USA POB SUBDIVISION, **ADDITION TO**

APPLICATION NUMBER 4 DATE May 21, 2015

APPLICANT USA POB Subdivision, Additon to

DETAIL SITE PLAN

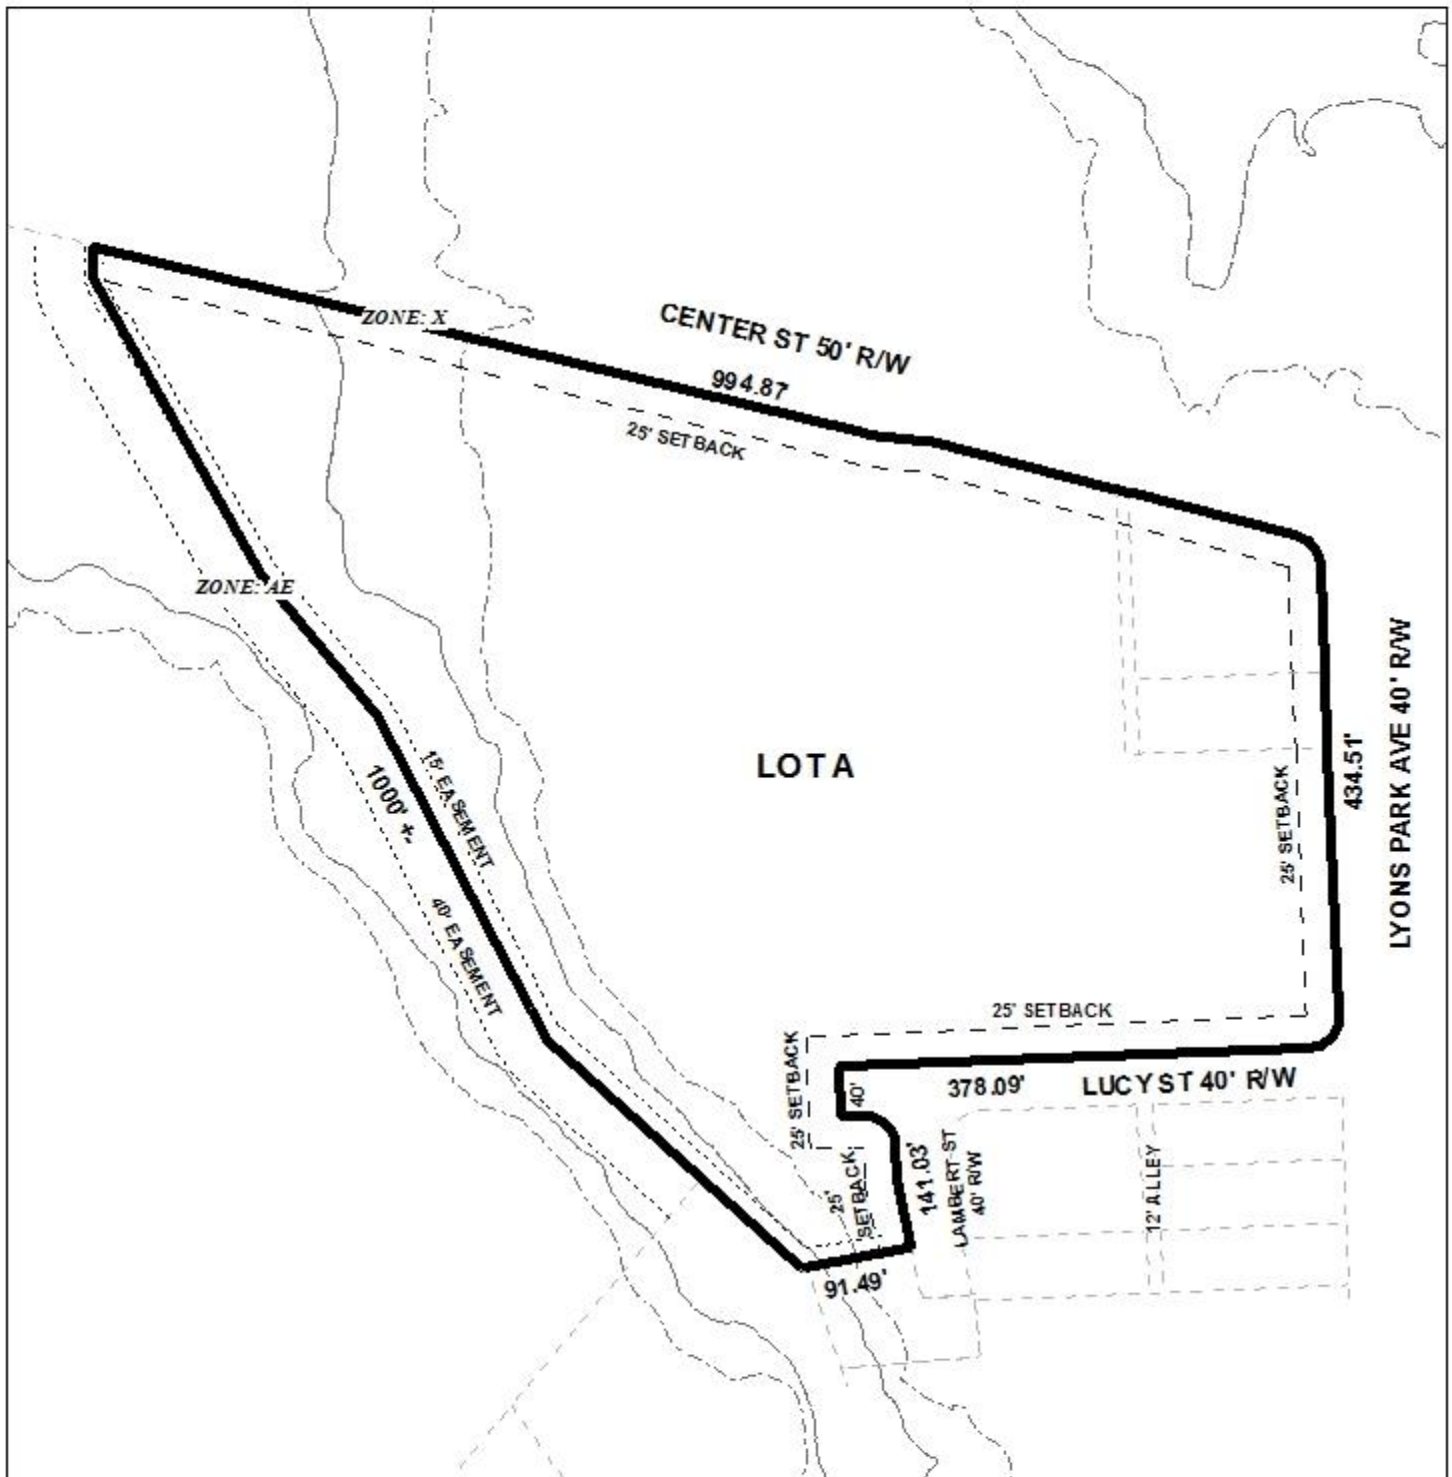
- D. Correct the spelling of “SPRINGHILL” to “SPRING HILL” and “MLK JR AVE” to “ST STEPHENS RD” in the vicinity map.
- E. Provide the Surveyor’s, Owner’s (notarized), Planning Commission, and Traffic Engineering signatures.

- G. Show the recording information for the vacated Right-of-Way labeled as “12’ ALLEY – TO BE VACATED”.
- H. Provide an updated Plat to Engineering Dept. for review prior to submittal for City Engineer’s signature.

It should be noted that the plat depicts a 12' alley to be vacated. The Street Vacation process should be completed prior to the signing of the Final Plat, if approved.

It should be pointed out that the preliminary plat depicts a 15' wide access easement along the southwestern lot line of the proposed lot. If approved, a note should be placed on the Final Plat stating that no permanent structure(s) can be placed or constructed in any easement.
